STAFF RECOMMENDATION
1605 Douglas Avenue
March 20, 2019

Application: Demolition; New Construction—Infill; Setback Determination
District: Eastwood Neighborhood Conservation Zoning Overlay
Council District: 06
Base Zoning: R6
Map and Parcel Number: 08302017800
Applicant: Lynn Taylor, Designer
Project Lead: Sean Alexander, sean.alexander@nashville.gov

Description of Project: The applicant proposes to demolish a non-contributing building and construct a new duplex. The building will have two nearly identical front-gabled forms attached with a shorter and narrower connection, giving the building the massing of being a house-behind-a-house.

Figure 2. Left side Elevation showing two nearly identical masses with smaller connection.

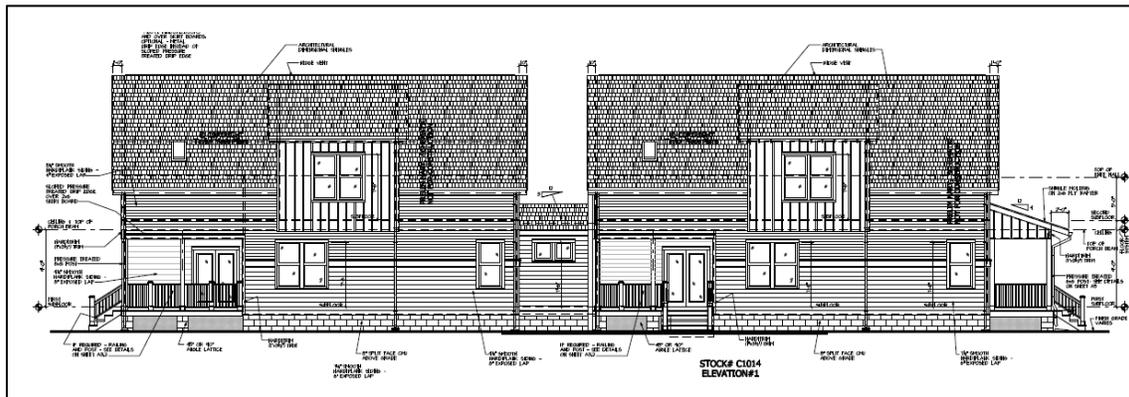
The proposed building is a duplex because it contains two attached dwellings, but the form is unlike that of a traditional duplex. The proposed infill would have two distinct masses, one behind the other, and roughly equal in size at twenty-two feet (22') wide and forty-six feet (46') deep, attached by a shorter and narrower connection (see Figure 2). The result is a structure that spans nearly one hundred, eight feet (108') with a "house behind a house" massing, a form that does not exist in the historic district.

The first story and the majority of the upperstories will be twenty-two feet (22') wide. Historic houses in the surrounding area are typically between twenty-eight feet (28') and thirty-two feet (32') in width, but the easement along the left side of the property significantly reduces the width of the potential building area. The upperstory will have projecting bays increasing portions of the building's width to twenty-five feet (25'): two bays on the left side would be fourteen feet (14') wide and project two feet (2'), and four bays on the right side would be five feet (5') wide and project one foot (1'). Projecting and cantilevered upperstory bays are not typical of historic houses in the surrounding area, which is generally composed of one-story and one and one-half-story houses. However the bays on the current proposal are relatively small portions of the building and because the building is atypically narrow staff finds that their additional width could be appropriate if not combined with the inappropriately tall proposed eave and ridge heights.

Given that the sewer easement reduces the buildable area of lot by nearly half, staff finds that the width of the new building with projecting bays could be appropriate. However, the ridge height of the proposed infill is two feet (2') taller than any historic house in the surrounding area, the eave height is taller than the predominantly one-story and one and

one-half-story context, the depth of the house is significantly greater than that of historic houses, and that the house-behind-a-house form does not exist anywhere in the district historically and would not be appropriate.

Staff finds that the proposed new construction is not compatible with the historic context and does not meet Sections II.B.1.a. and II.B.1.b. of the design guidelines.

SITE PLAN

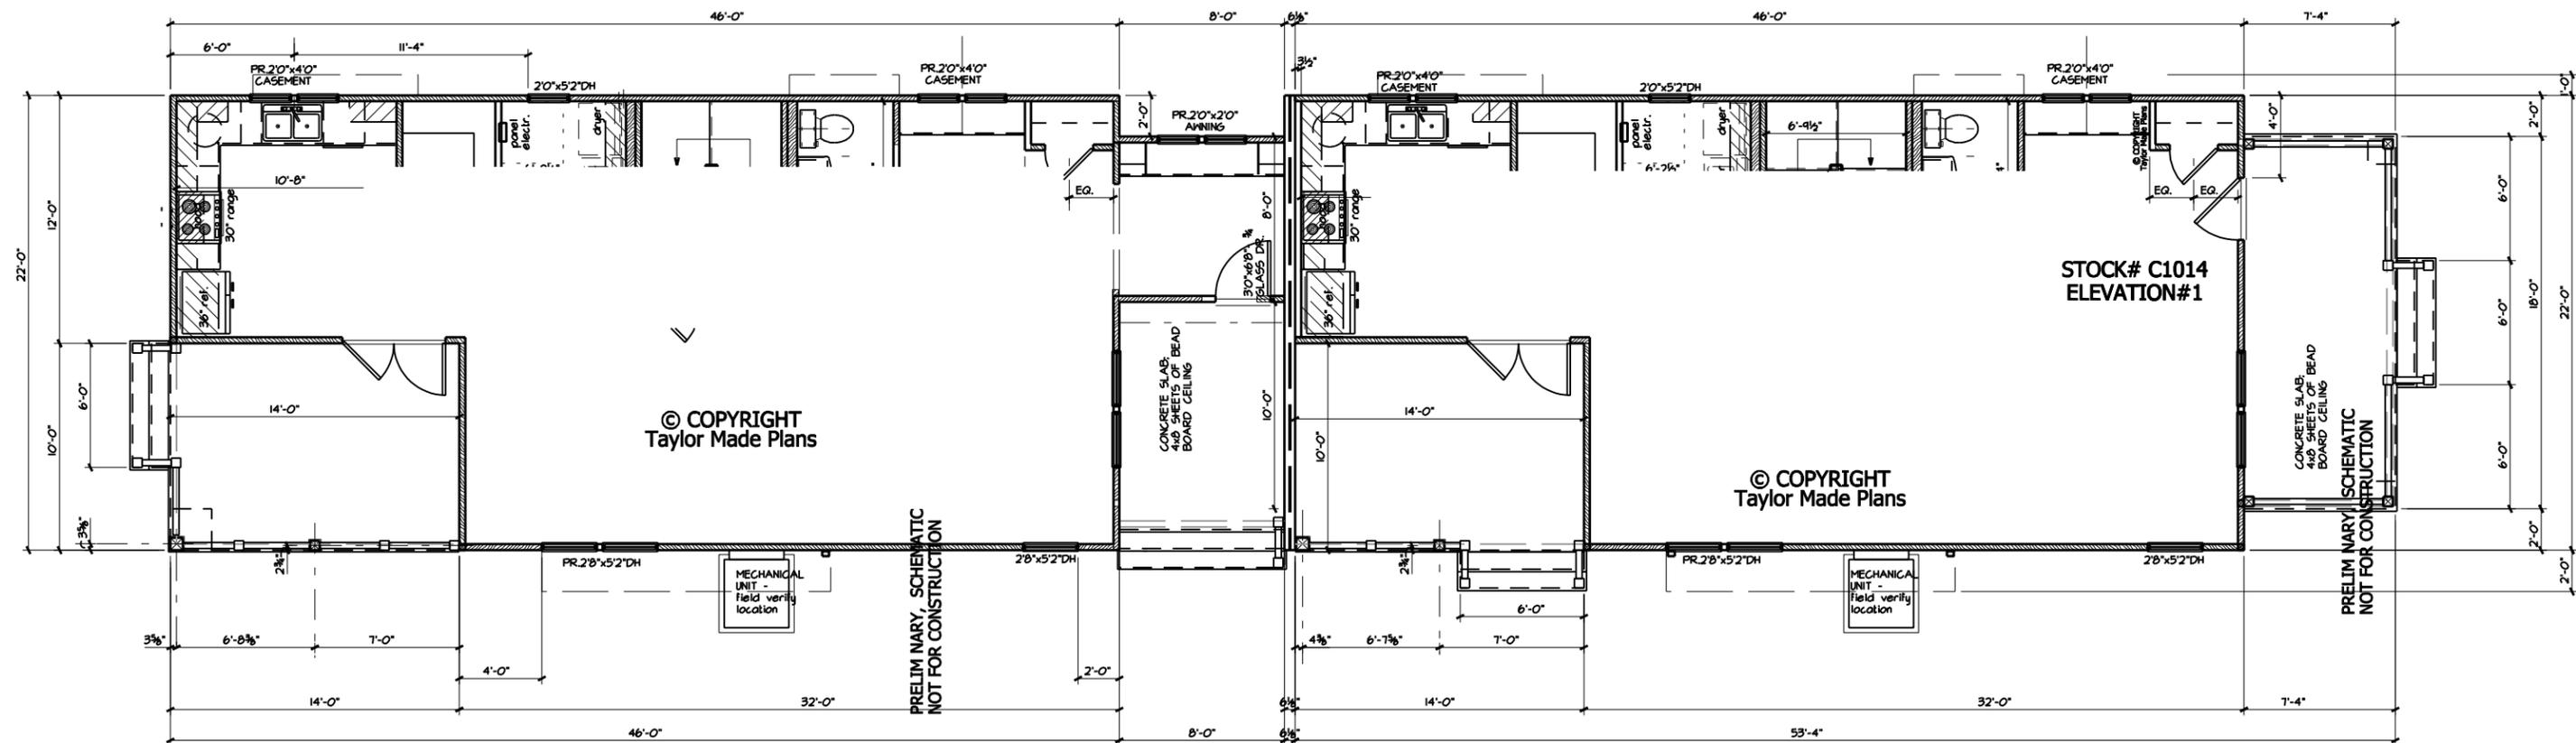
The new construction will be narrower than typical of surrounding historic houses at only twenty-two feet (22') wide, with bays extending portions of the upperstory two feet (2') wider to the left and one foot (1') wider to the right. The resulting twenty-one foot (21') left side setback is greater than the typical space between buildings, but is necessary because the easement reduces the buildable area of the lot. In the current proposal, the projecting bays and the buildings' primary eaves on the left side project two feet (2') over the easement, while the eaves on the bays project four feet (4') into the easement. The HVAC units are also proposed to be located in the easement.

The bays on the right side will project one foot (1') into the required side setback buffer, for which the applicant requests a determination for a four foot (4') setback. Because the bays on the current proposal are relatively small portions of the building, and because the buildable area of the lot is narrow, staff finds that the additional width may be appropriate on the right side.

An easement encroachment would need to be granted by the Water Services Department before any portion of the building can be constructed over the sewer easement on the left. If approval to encroach into the easement is not granted, a revision to the design may be necessary, therefore staff cannot fully analyze the project in regards to Section II.B.1.c of the design guidelines until Water Services has made their determination.

Appurtenances & Utilities: The location of the HVAC units is shown on the site plan as being on the left side of the building, at the approximate midpoints of each unit.

Staff finds these locations would be appropriate and that the project will meet section II.B.1. i. of the design guidelines. (Note – this HVAC location is in the sewer easement. If this location is not permitted by Water Services, Staff asks that the HVAC be located on the rear façade, or on a side façade beyond the midpoint of the house.)
